**CONNECTICUT SITING COUNCIL**

**PETITION OF NORTH ATLANTIC TOWERS, )  
LLC AND NEW CINGULAR WIRELESS PCS LLC )     **PETITION NO. 973**  
TO THE CONNECTICUT SITING COUNCIL )  
FOR A DECLARATORY RULING THAT NO )  
CERTIFICATE OF ENVIRONMENTAL )  
COMPATIBILITY AND PUBLIC NEED )     **MARCH 3, 2011**  
IS REQUIRED TO REPLACE AND EXPAND )  
AN EXISTING LATTICE TOWER LOCATED )  
AT 880 ANDREW MOUNTAIN ROAD IN )  
NAUGATUCK, CONNECTICUT )**

**SUPPLEMENTAL SUBMISSION**

Drawing Title:  
**OVERALL SITE PLANS**

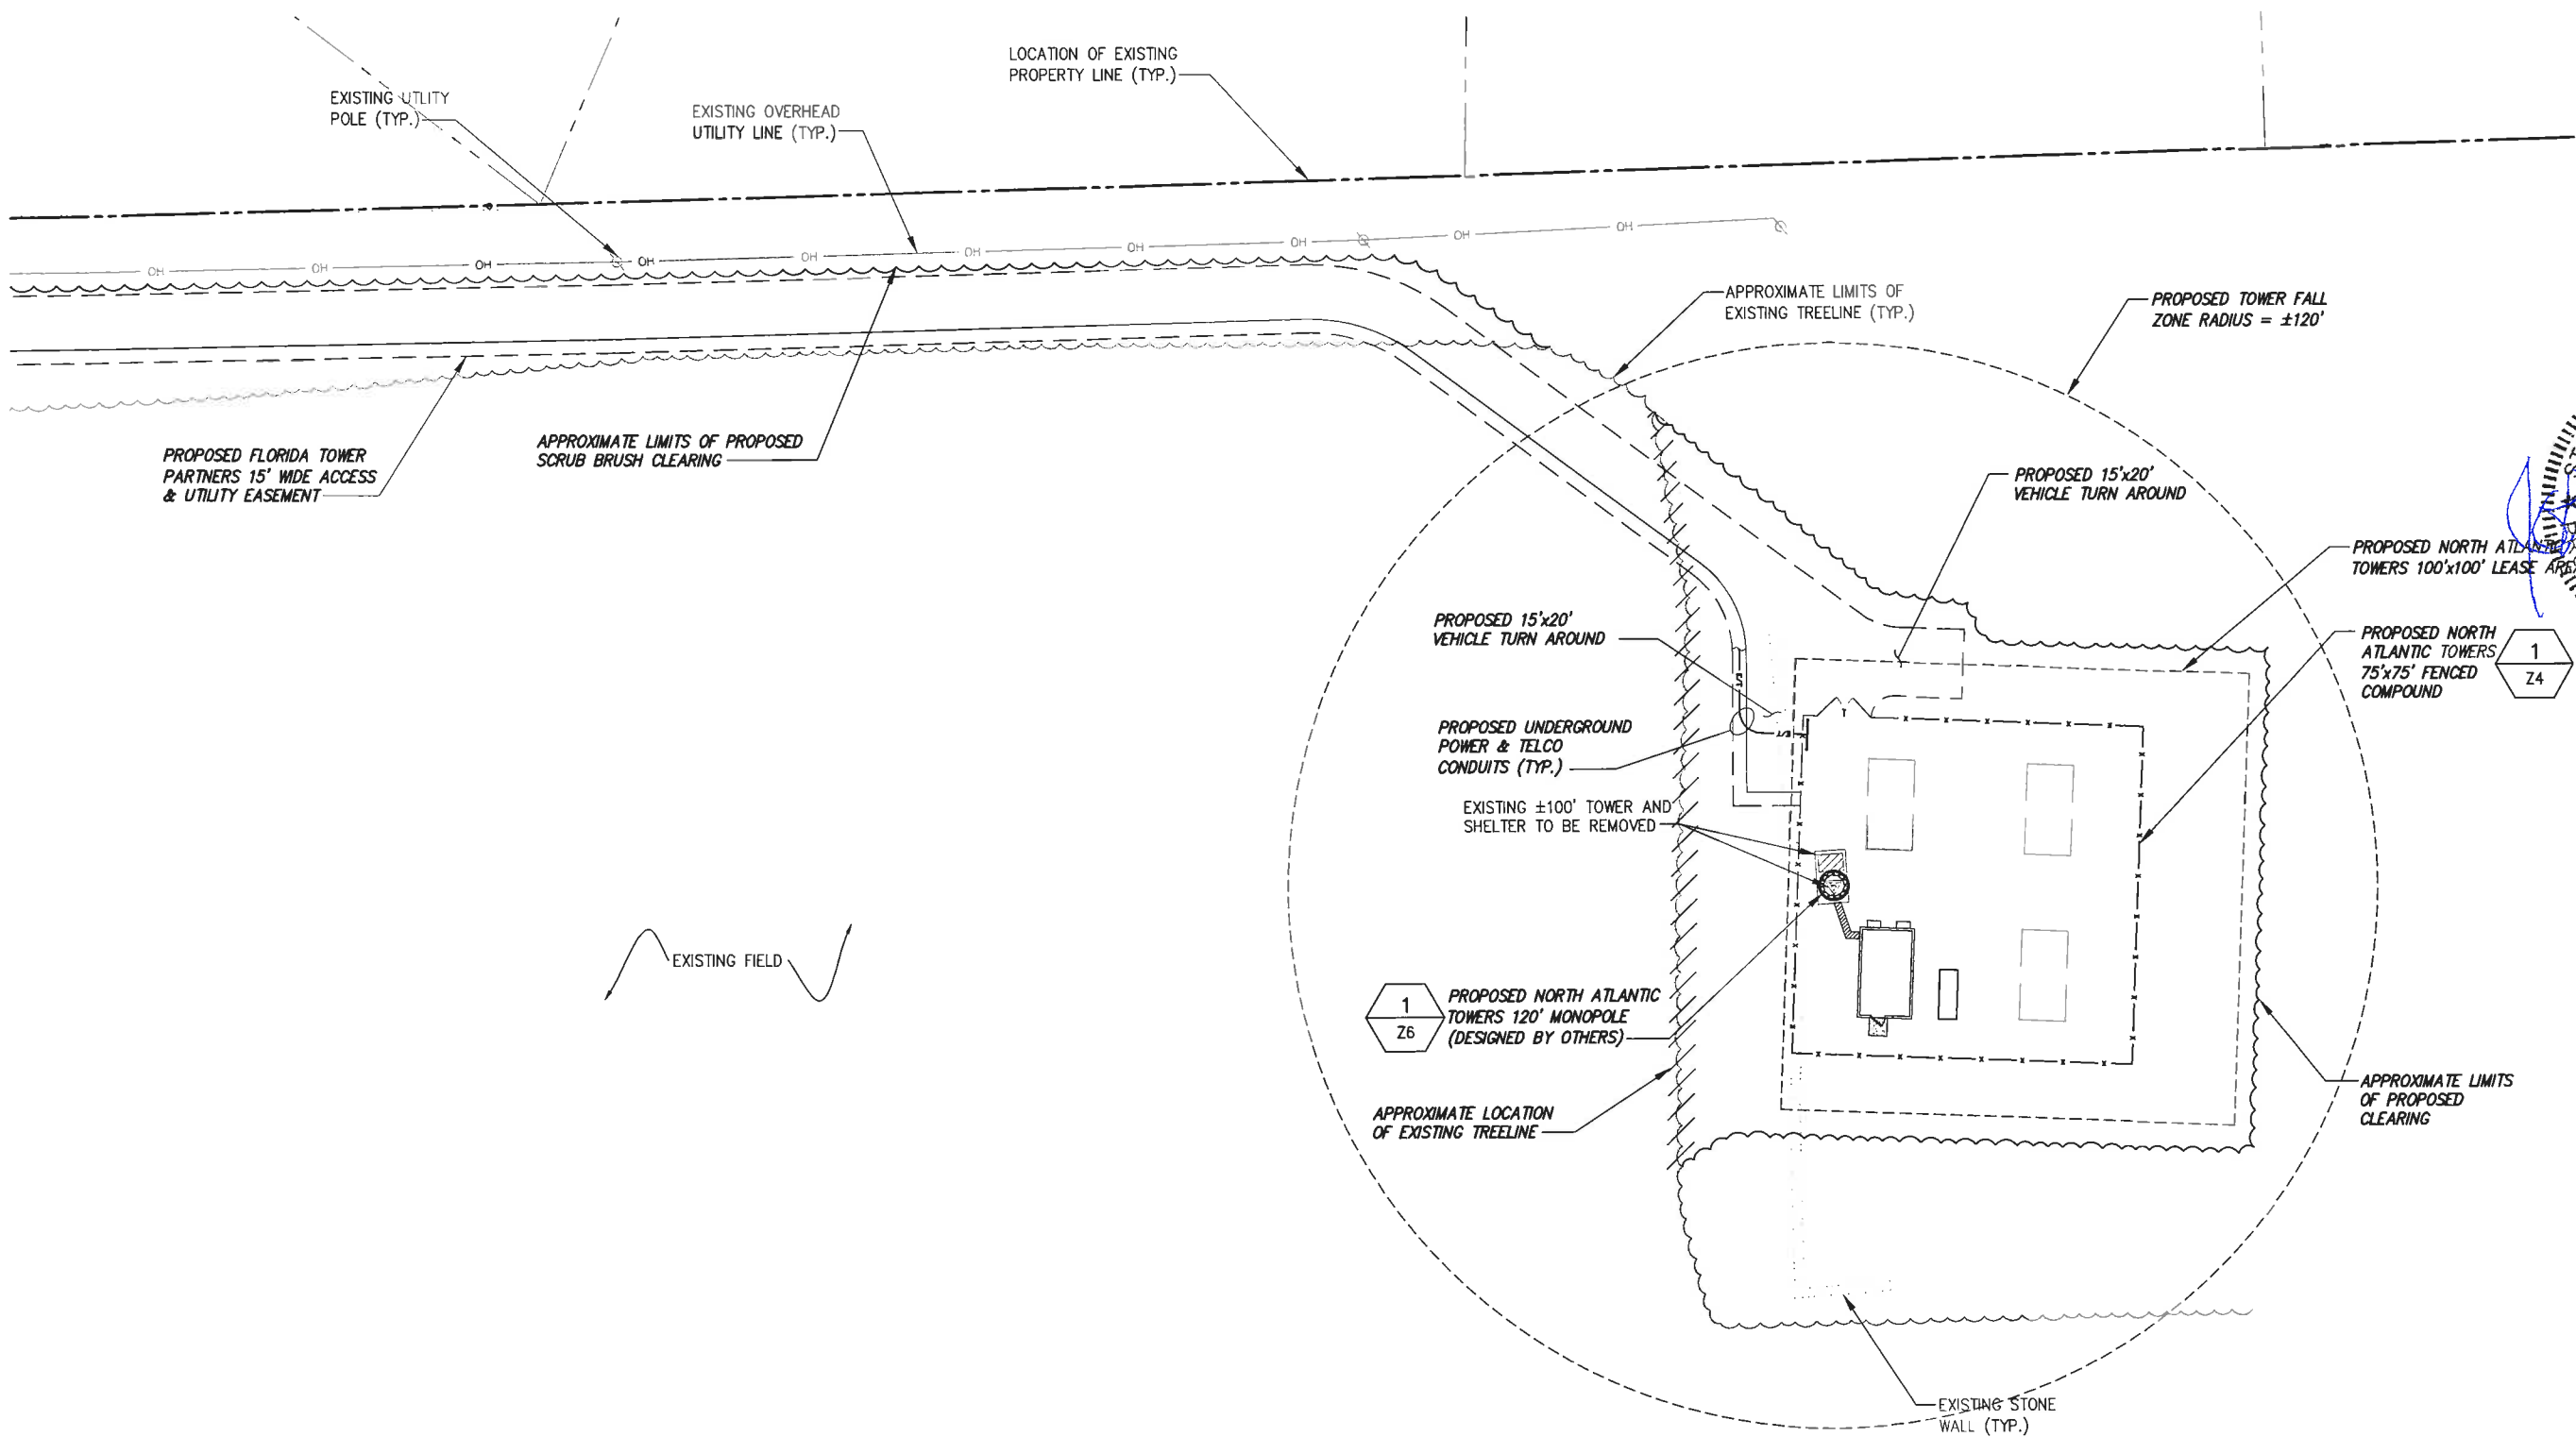
North Atlantic Towers, LLC and New Cingular Wireless PCS, LLC ("AT&T") respectfully submit this supplemental information including updated site plan drawings (Overall Site Plan, Overall Site Layout and Grading Plan) depicting a shift of the proposed access drive to the north. This shift will not result in any additional tree clearing.
